## CALIFORNIA COASTAL COMMISSION

## Addendum

January 5, 2009

Subject: Addendum to **Th 13c**, Coastal Commission Permit Application  
**#6-08-96 (UCSD & Sanford Consortium)**, for the Commission Meeting  
of 1/8/09

EXHIBIT NO. 1
APPLICATION NO.
<b>6-08-96</b>
Revised Location
Map
<b>51</b>
California Coastal Commission

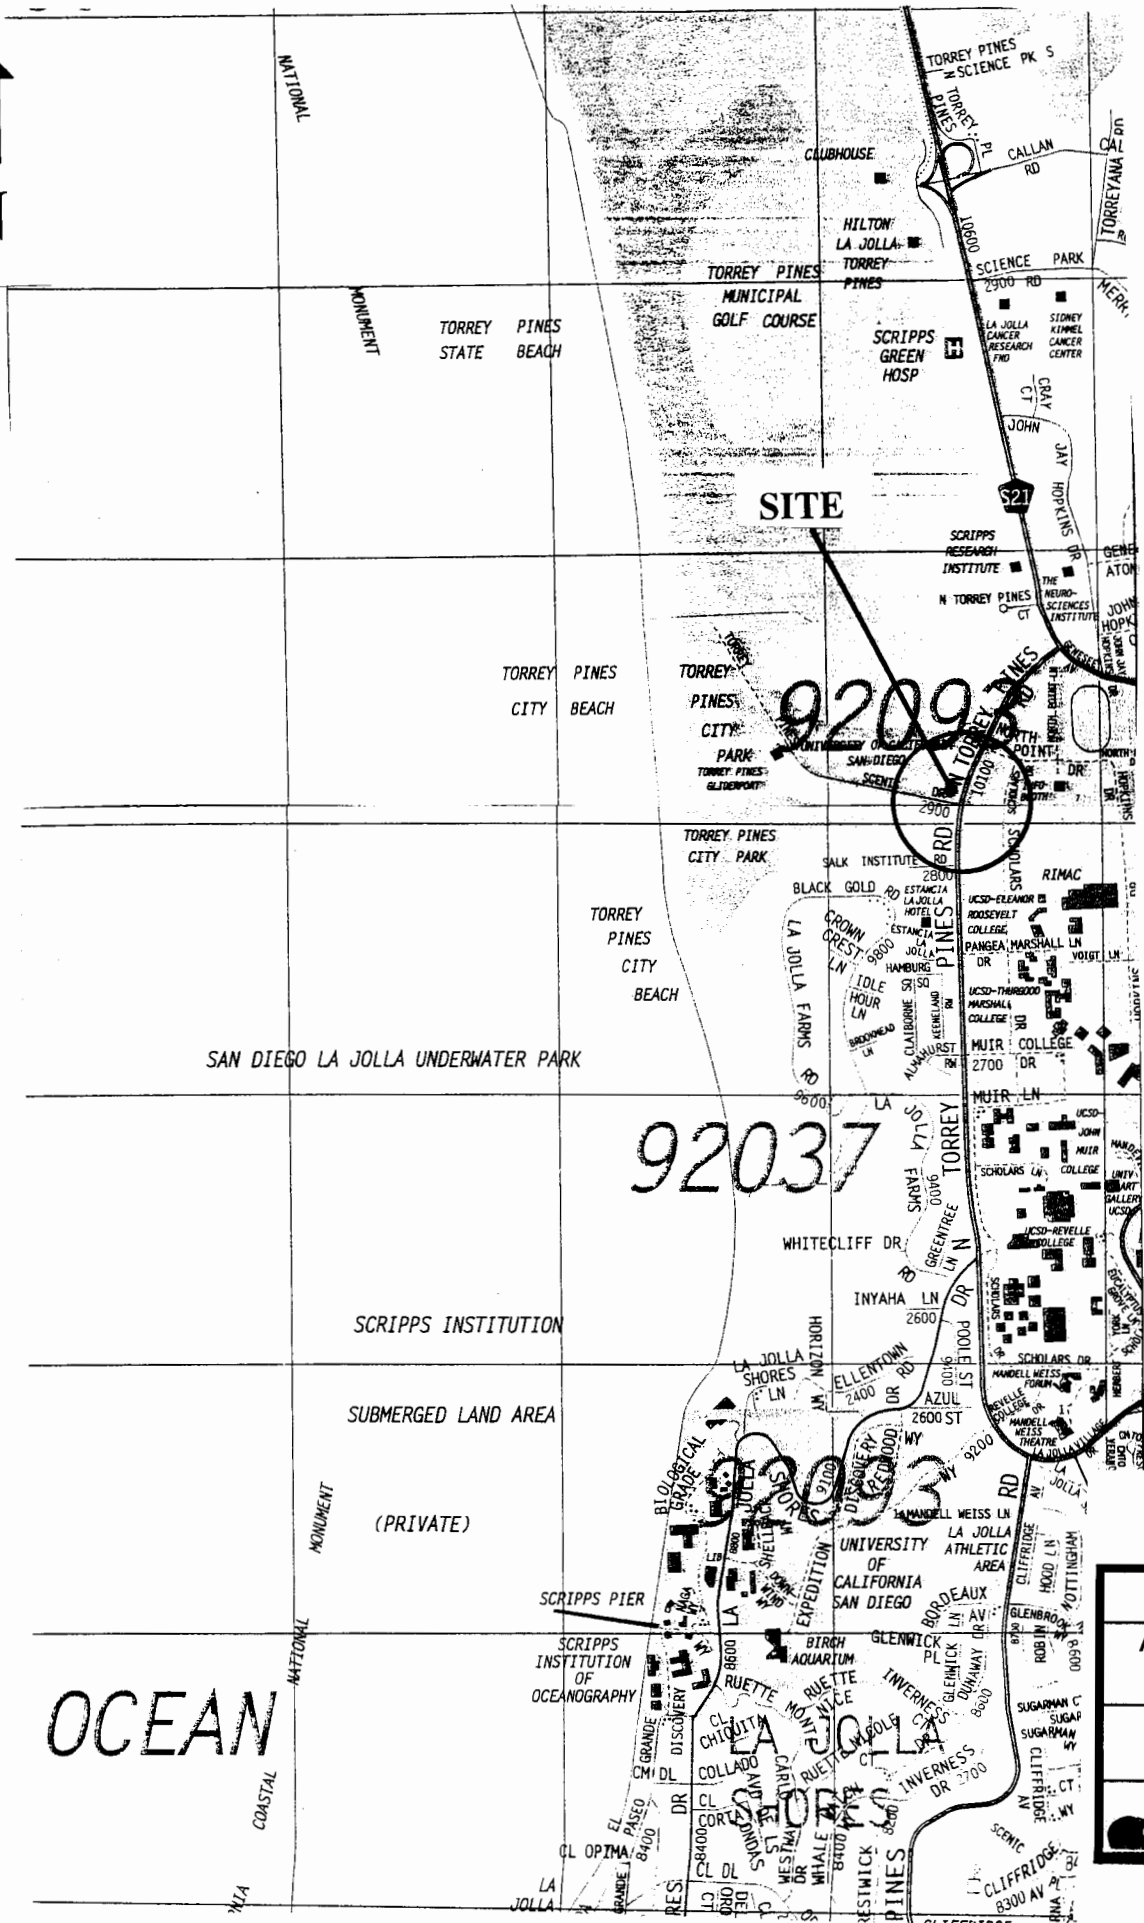
9. Several new exhibits shall be added to the staff report. Exhibit No. 1 is the revised Location Map with the site circled. Exhibit No. 7 is the 20-foot wide view corridor (pursuant to Special Condition No. 2) and Exhibit Nos. 8-13 are colored exhibits provided by the applicant which more clearly show the gliderport in relationship to the subject site, etc.

<b>EXHIBIT NO. 7</b>
<b>APPLICATION NO.</b>
<b>6-08-96</b>
Approximate location of view corridor (in concept only) pursuant to Special Condition No. 2(b).
California Coastal Commission <b>53</b>

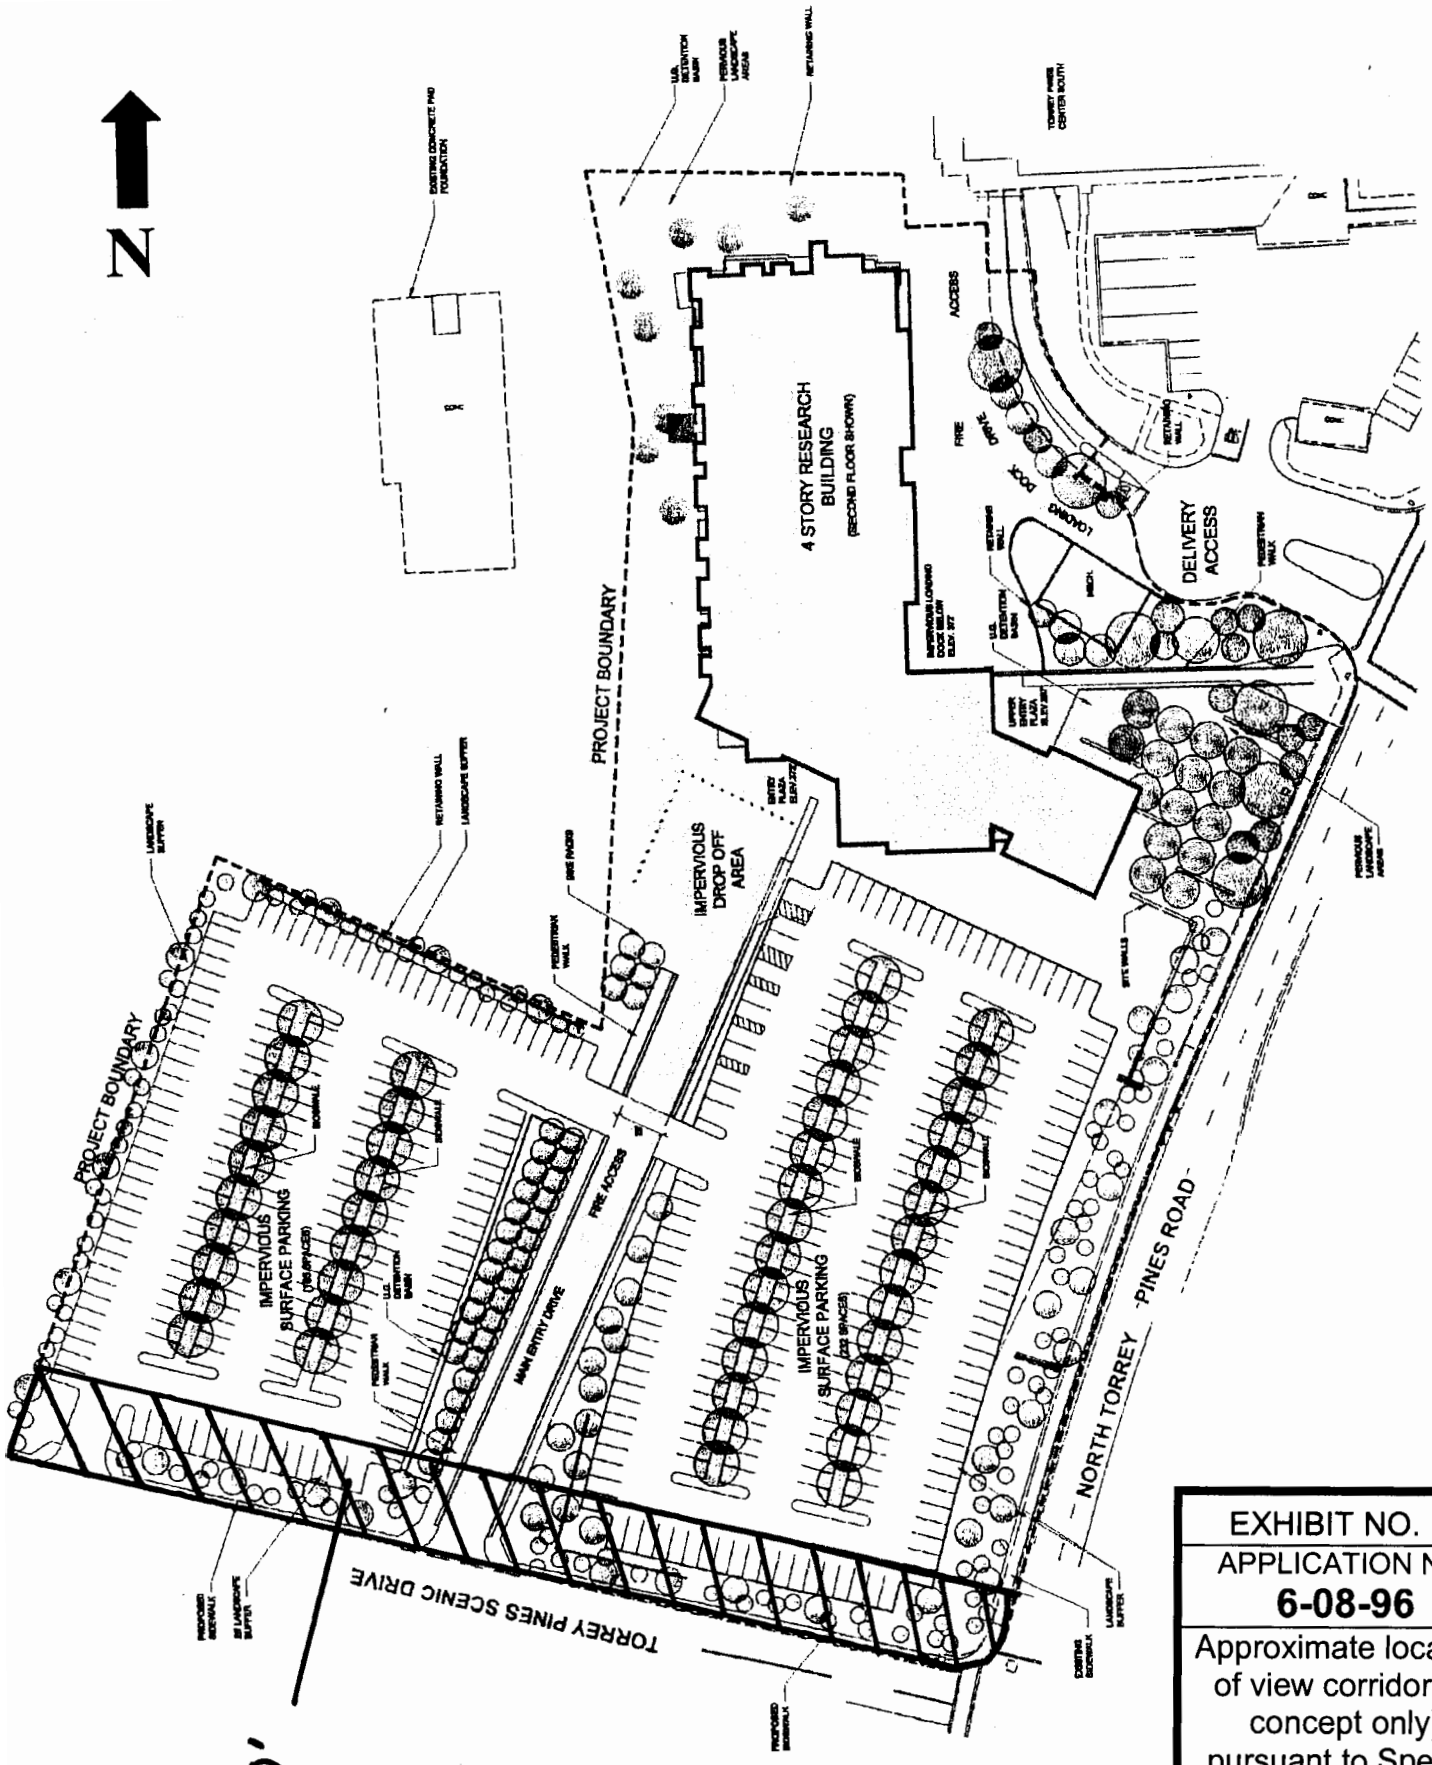
b. A view corridor a minimum of ~~30~~ 20 feet wide shall be preserved along the southern portion of the property adjacent to Torrey Pines Scenic Drive.

All proposed landscaping in this area shall be maintained at a height of three feet or lower (including raised planters) to preserve views looking west towards the ocean. No tall trees are permitted in this area. Tall trees are permitted outside of the view corridor on the northern portion of the parking lots for the purpose of screening the parking lots from public views from Torrey Pines Scenic Drive and North Torrey Pines Road.
